Comments on Wetland Watershed Budgets

Indirect Wetland Impacts

JOB NO.: 17186.GPJ
 BORING NO.: PZ-14A
 1 OF 1
 ELEV.:
 DRILL CREW: M. Graham / J. McDonald / S. Schwartz
 BORING DEPTH: 5.5
 DATE: 6/21/17

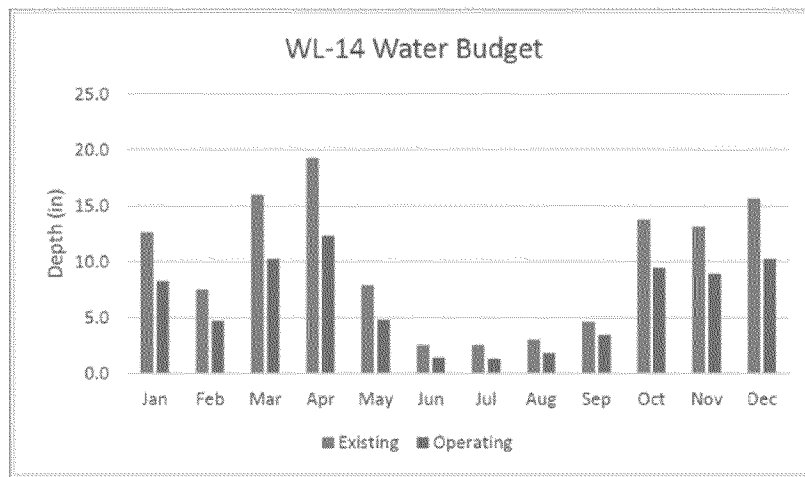
Soil Boring PZ-14A is ion WL B3.

JOB NO.: 17189.GPJ
 BORING NO.: SB-1
 1 OF 1
 DRILL CREW: M. Graham / J. McDonald
 BORING DEPTH: 5.6
 REVIEWED BY: M. Gotham DATE: 6/21/17

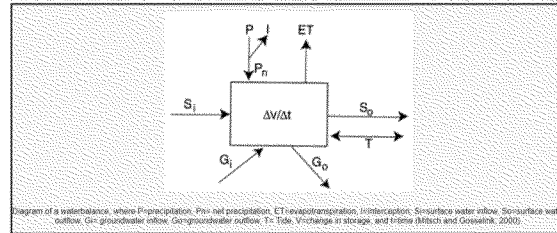
SB-1 should be from near PZ-1/1A

Wetland 14/14a/15b

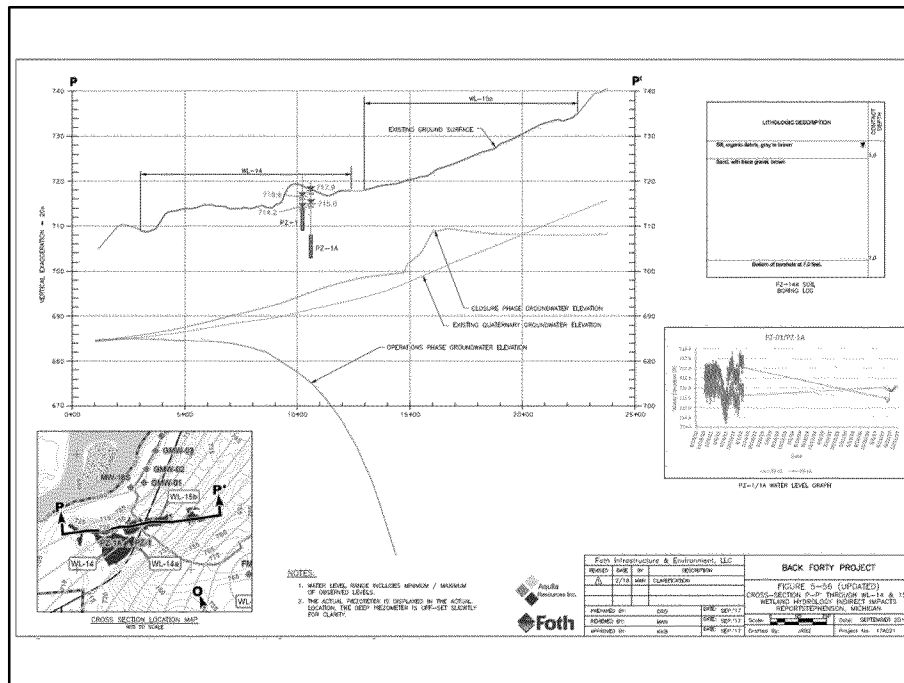
River Road is a barrier to surface hydrology. No evidence of adequate equalization through River Road. How does the wetland watershed portrayed in this figure support WL-14?

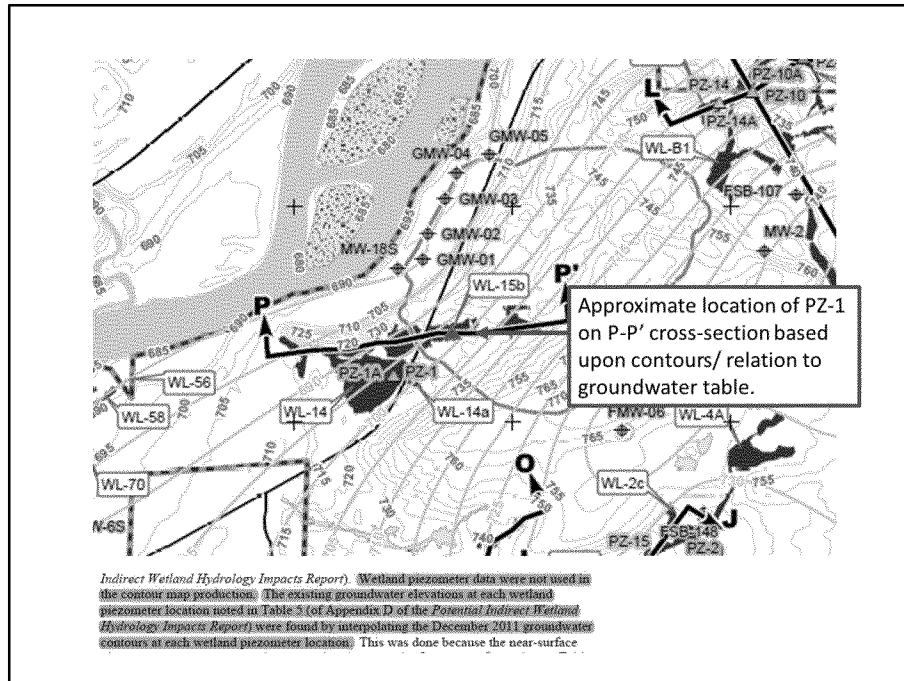
This figure represents the location of the piezometer nest in relation to the groundwater table.

PZ1/1A is shown on Table 1 (In March response) as a target for the groundwater model calibration. It is also shown on Figure 4-4 (Updated) as having a residual.

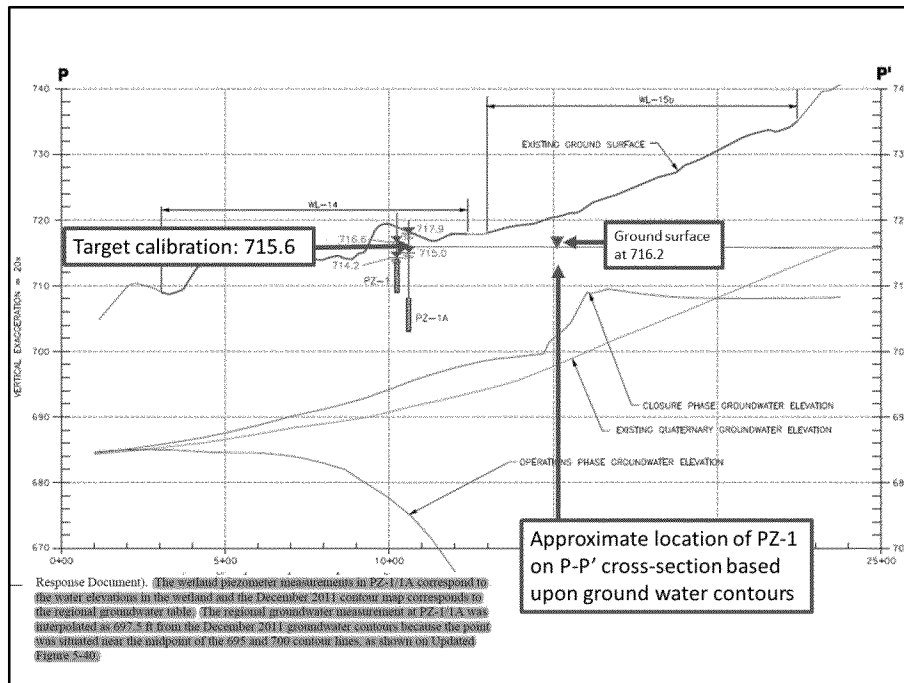
PZ-1/ PZ-1A is shown on the cross-section contours for P-P'; however, the location of PZ-1/PZ-1A is off-set and is represented in cross-section as being in WL-14. Figure 5-56 states that the piezometer is off-set but shown in the correct location. This is the incorrect location of the piezometer since the purpose of cross-section (P-P') is demonstrate the groundwater elevation at PZ-1/PZ-1A in comparison with the modeled groundwater elevation (aka regional groundwater table). This slide shows where the location of PZ-1/PZ-1A would exist if it was located on the P-P' cross-section. The following slide shows the onset location of the piezometer relative to the cross-section and representation of the groundwater model.

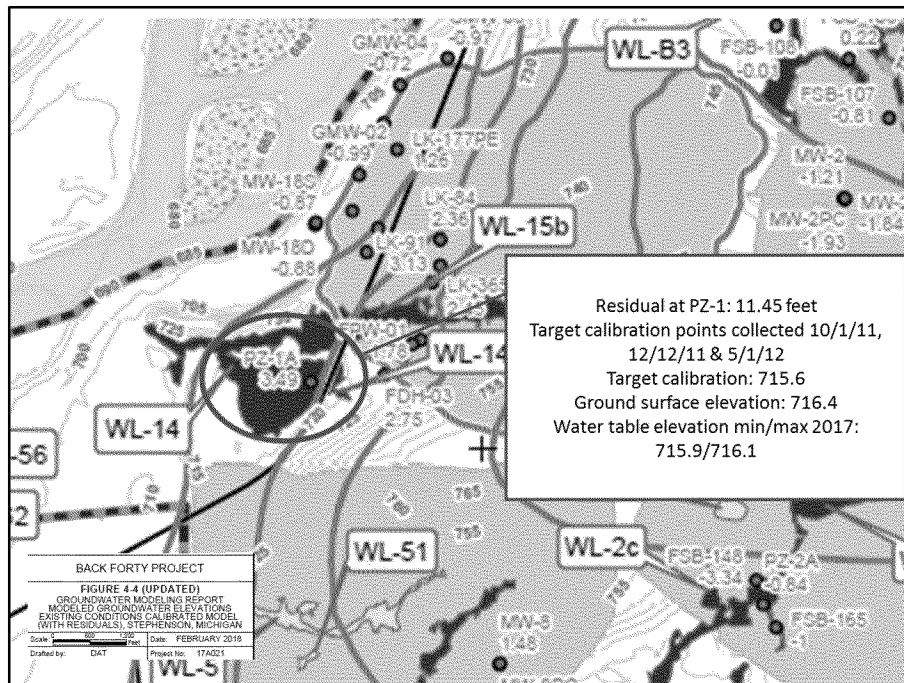
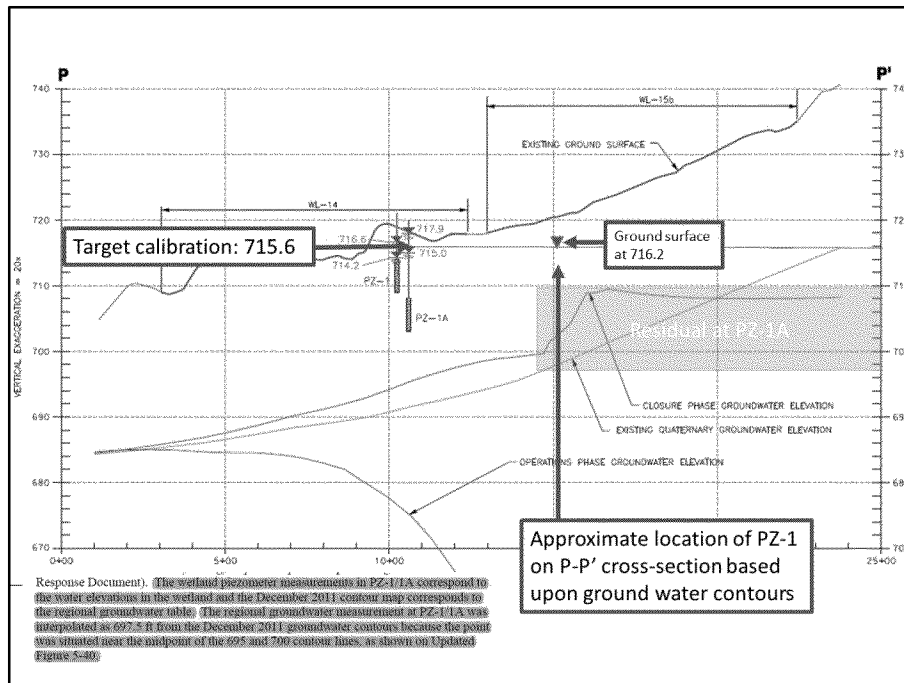
This slide shows cross-section P-P'. Note that on this slide, PZ-1/PZ-1A is shown in WL-14. However, this is the incorrect location. The P-P' cross-section is significantly off-set from the actual location of PZ-1/ PZ-1A. If you follow the elevation contour on the previous slide, the piezometer nest is located between in about the middle of WL-15. This slide shows approximately where the piezometer nest would sit relative to the regional water table if the piezometer nest were accurately represented on the cross-section. If the piezometers were accurately represented on the cross-section, we would have a better representation of the water table elevation that is both supported by the calibrated targets, piezometer data and the residuals.

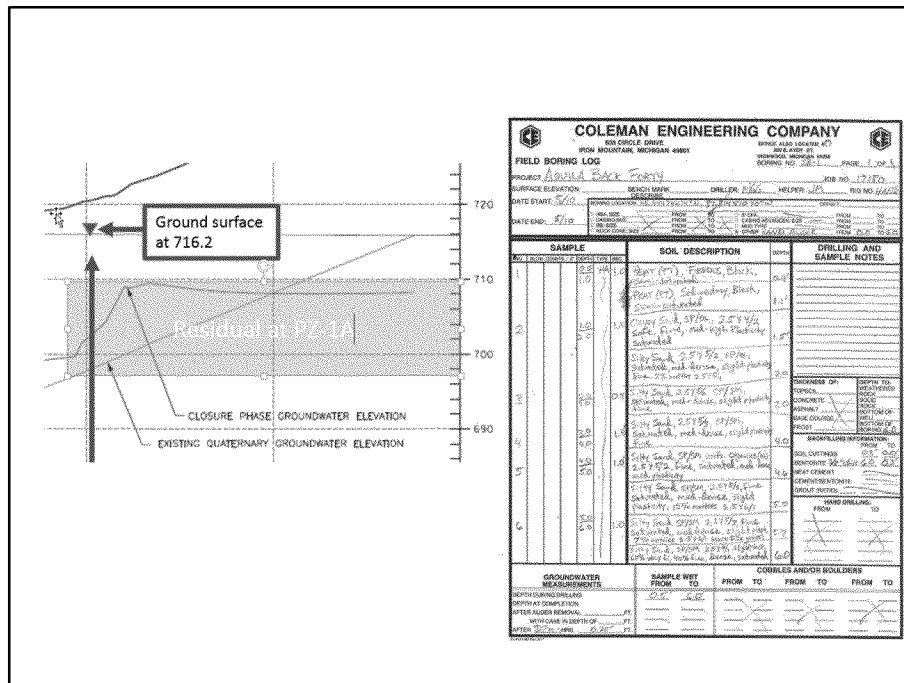
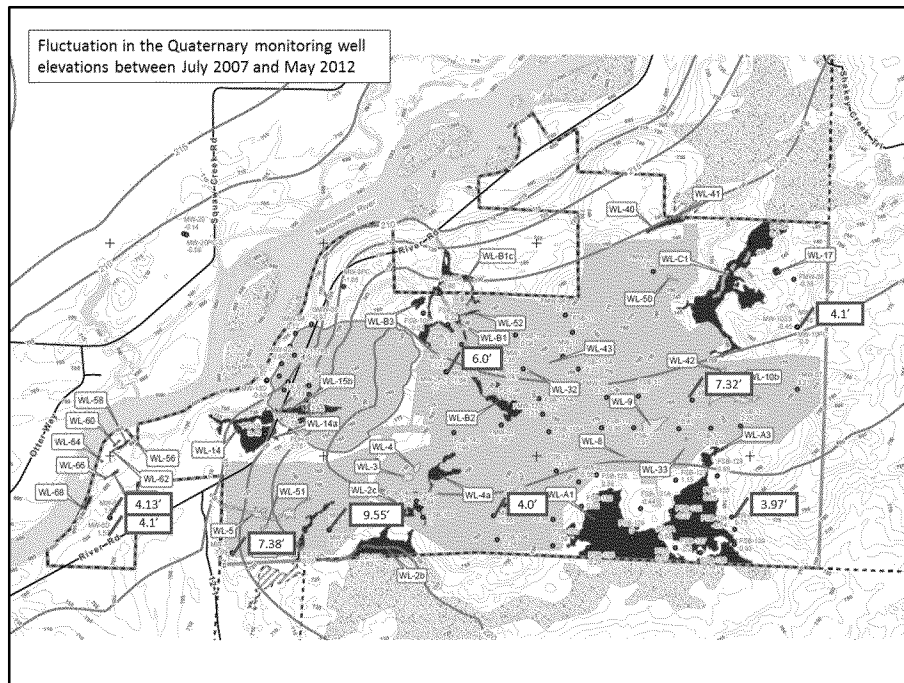
This slide shows cross-section P-P'. Note that on this slide, PZ-1/PZ-1A is shown in WL-14. However, this is the incorrect location. The P-P' cross-section is significantly off-set from the actual location of PZ-1/ PZ-1A. If you follow the elevation contour on the previous slide, the piezometer nest is located between in about the middle of WL-15. This slide shows approximately where the piezometer nest would sit relative to the regional water table if the piezometer nest were accurately represented on the cross-section. The distance to the modeled water table at this location is comparable to the residual in the model of 11.45 feet. I believe that if the piezometers were accurately represented on the cross-section, we would have an accurate representation of the water table elevation that is supported by the calibrated targets, piezometers and the residual.

The soil boring shows that the area above the residual to ground surface is saturated sand.

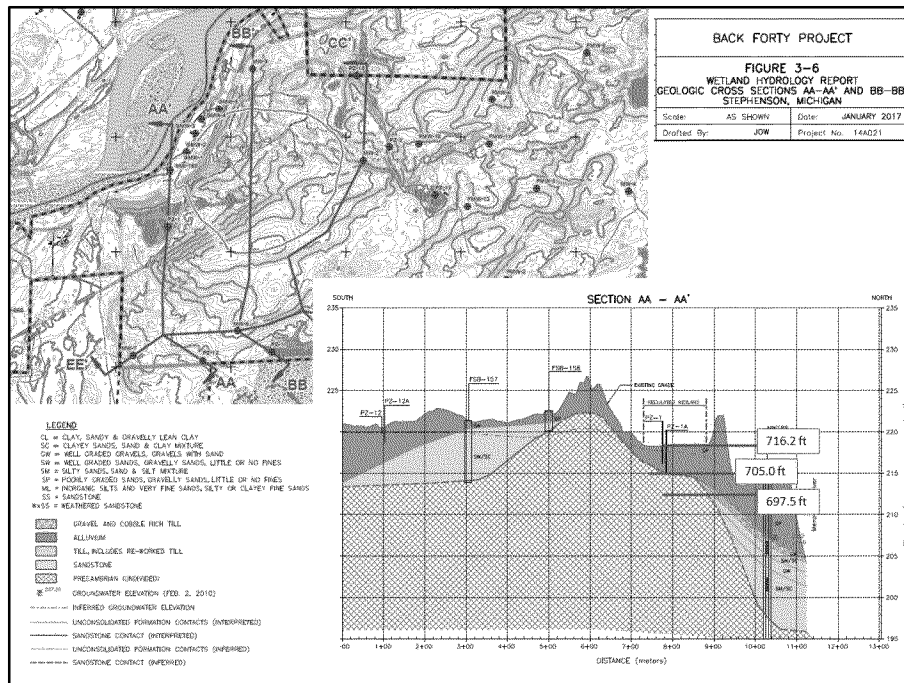
The values represented on this slide have more than one season of target data, and they include collection during the growing season which represents seasonal variation in the water table. All of these targets were collected from the Quaternary. Several of the target locations that we are interested in, such as FMW-05, FMW-08, PZ-1A, PZ-5/PZ-5A do not have any data collection periods during the growing season. This range of elevation is well within the fluctuation zones of what would impact wetland hydrology.

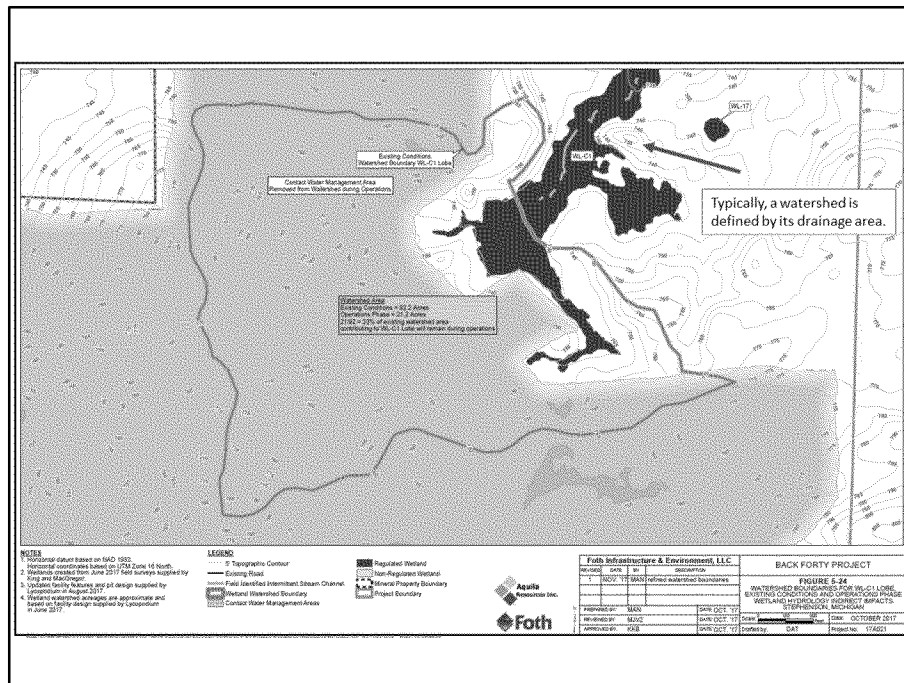
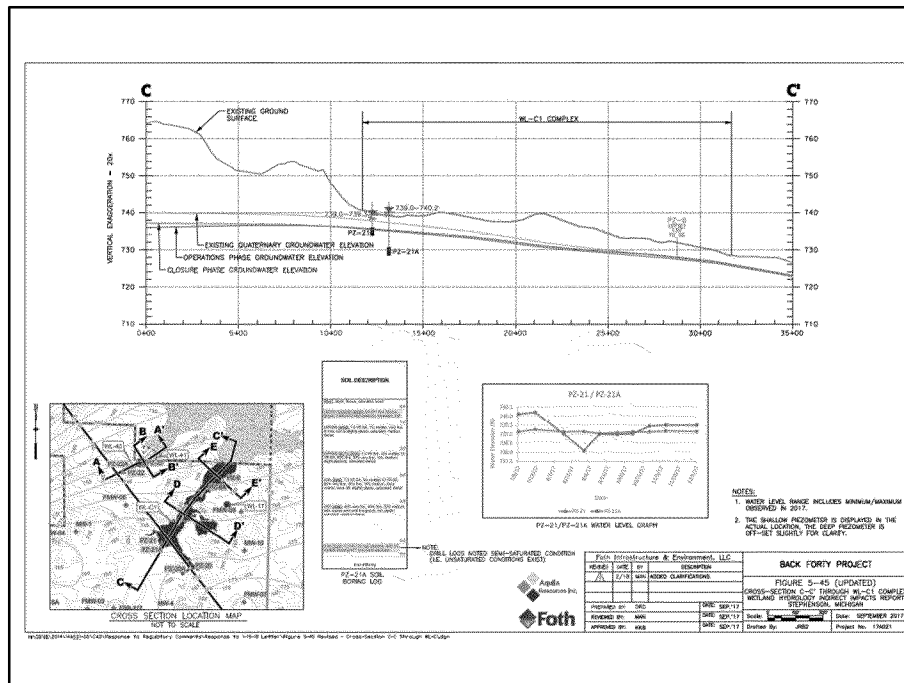
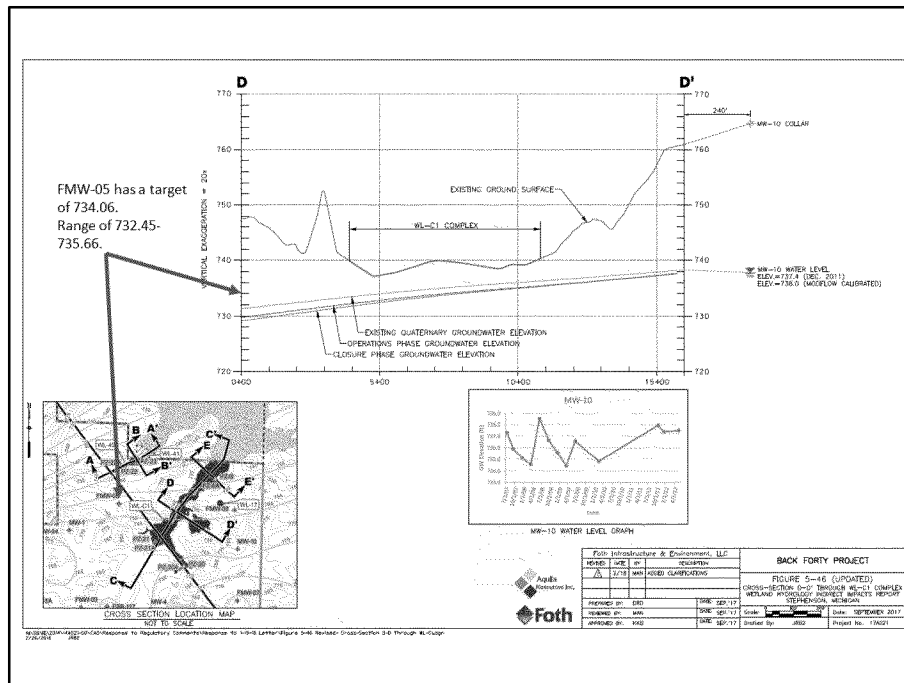
Why was the "lobe" watershed determined to be in this location?

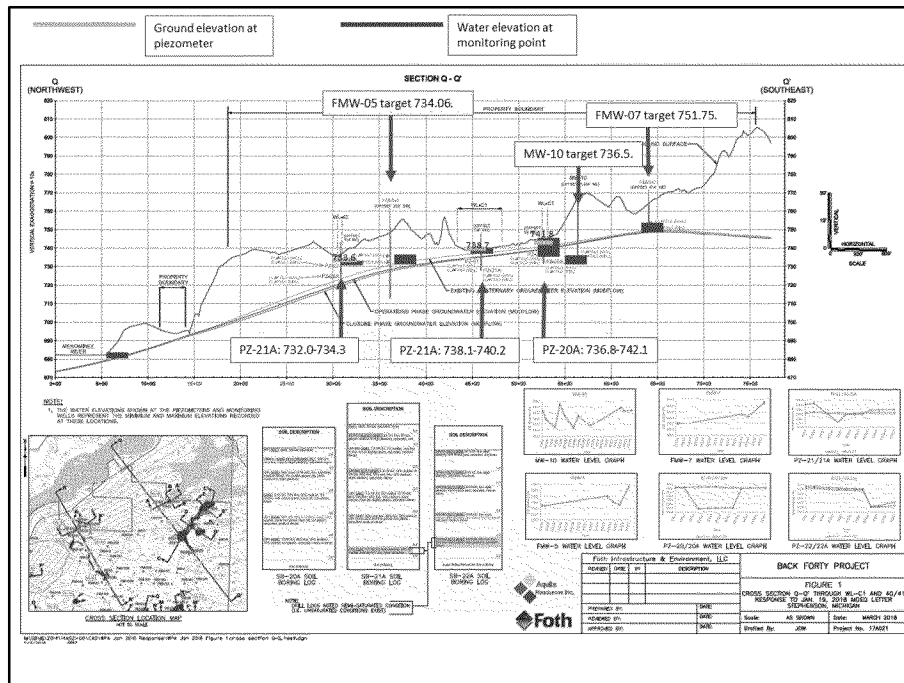
At some place, the GW elevation has to go up.

Cross-section is off-set from PZ21/21A in WL-40/41 and FMW-07

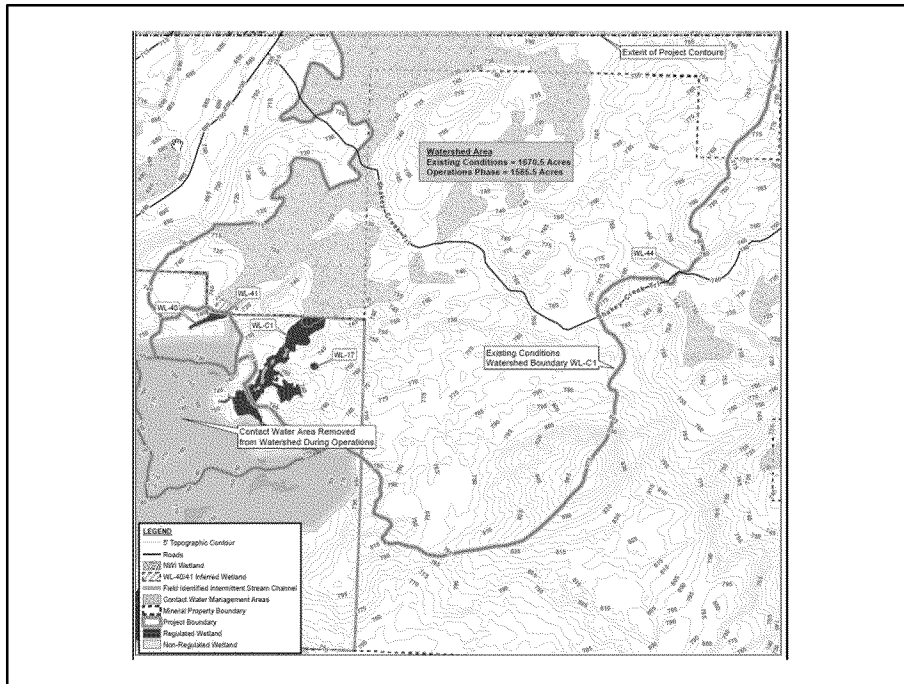
Where is the separation of the perched vs the groundwater driven portions of the wetland complex?
